Access Compliance Report

Public Rights-of-Way

(Pedestrian Signals)

Intersection ID: N/A	Main Street:	Cross Street: N/A	Location: N/A
ADA ID: 175CA6508133	Signal Type: One Push Button-Non APS	Overall Compliance: No	Severity Score: BTN 1: N/A BTN 2: N/A No BTN: N/A
Codes/Mitigation Info/Possible Solution		Field Measurements/Component Compliance

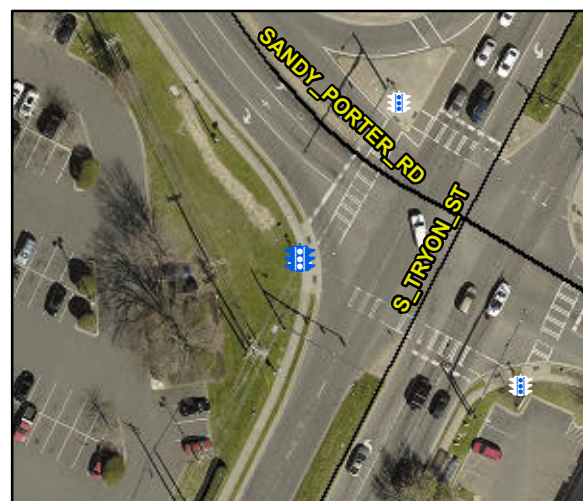
Surveyor Notes: TEXT HT 3/8

PROW/ADA: R410.6, TMUTCD 4e.08, R404.2, R404.3, R406.2, R404.7.3

Compliance	Description	Data	Compliance	Description	Data
	Button Count	Button1	N/A	Distant to Additional Button (in)	N/A
	Additional Button Present?	No		Additional Button ID	N/A
N/A	Signal Buttons Required?	N/A	N/A	Additional Ped Posts Required	N/A
	How Many Ped Street Xings?	2		Located In An Island/Median?	No
N/A	B 1 Sign Present?	Yes	N/A	B 2 Sign Present?	N/A
Yes	B 1 Sign Purpose?	Yes	N/A	B 2 Sign Purpose?	N/A
No	B 1 Sign Lettering & Contrast?	No	N/A	B 2 Sign Lettering & Contrast?	N/A
Yes	B 1 Parallel To XWalk?	Yes	N/A	B 2 Parallel To XWalk?	N/A
Yes	B 1 PAR to Button?	Yes	N/A	B 2 PAR to Button?	N/A
Yes	B 1 PAR to XWalk?	Yes	N/A	B 2 PAR to XWalk?	N/A
Yes	B 1 Clear Floor Space?	Yes	N/A	B 2 Clear Floor Space?	N/A
N/A	B 1 FWD Approach?	Yes	N/A	B 2 FWD Approach?	N/A
N/A	B 1 FWD Approach Constrained?	No	N/A	B 2 FWD Approach Constrained?	N/A
No	B 1 FWD Approach Reach (in)	25.0	N/A	B 2 FWD Approach Reach (in)	N/A

N/A	B 1 FWD Approach Width (in)	N/A	N/A	B 2 FWD Approach Width (in)	N/A
N/A	B 1 FWD Approach Obstruction?	Yes	N/A	B 2 FWD Approach Obstruction?	N/A
N/A	B 1 FWD Approach Obstruction Dist (in)	8.0	N/A	B 2 FWD Approach ObstructionDist (in)	N/A
N/A	B 1 PARA Approach?	Yes	N/A	B 2 PARA Approach?	N/A
N/A	B 1 PARA Approach Constrained?	No	N/A	B 2 PARA Approach Constrained?	N/A
No	B 1 PARA Approach Reach (in)	25.0	N/A	B 2 PARA Approach Reach (in)	N/A
N/A	B 1 PARA Approach Width (in)	N/A	N/A	B 2 PARA Approach Width (in)	N/A
N/A	B 1 PARA Approach Obstruction?	Yes	N/A	B 2 PARA Approach Obstruction?	N/A
N/A	B 1 PARA Approach Obstruction Dist (in)	8.0	N/A	B 2 PARA Approach ObstructionDist (in)	N/A
No	B 1 Clear Floor Space Slope (%)	7.5	N/A	B 2 Clear Floor Space Slope (%)	N/A
No	B 1 Clear Floor Space XSlope (%)	2.6	N/A	B 2 Clear Floor Space XSlope (%)	N/A
N/A	B 1 PAR Slope (%)	1.3	N/A	B 2 PAR Slope (%)	N/A
Yes	B 1 Height (in)	36.5	N/A	B 2 Height (in)	N/A

Yes	B 1 Clear Xing Direction?	ClearlyMarked	N/A	B 2 Clear Xing Direction?	N/A
	B 1 Crossing Direction	To SE		B 2 Crossing Direction	N/A
Yes	B 1 DistanceTo XWalk (in)	0.0	N/A	B 2 DistanceTo XWalk (in)	N/A
No	B 1 DistanceTo Curb (in)	115.0	N/A	B 2 DistanceTo Curb (in)	N/A
Yes	B 1 Diameter (in)	2.0	N/A	B 2 Diameter (in)	N/A

Possible Solutions: Replace Signal Push Button With APS Button on New Post. Remove & Replace Sign.
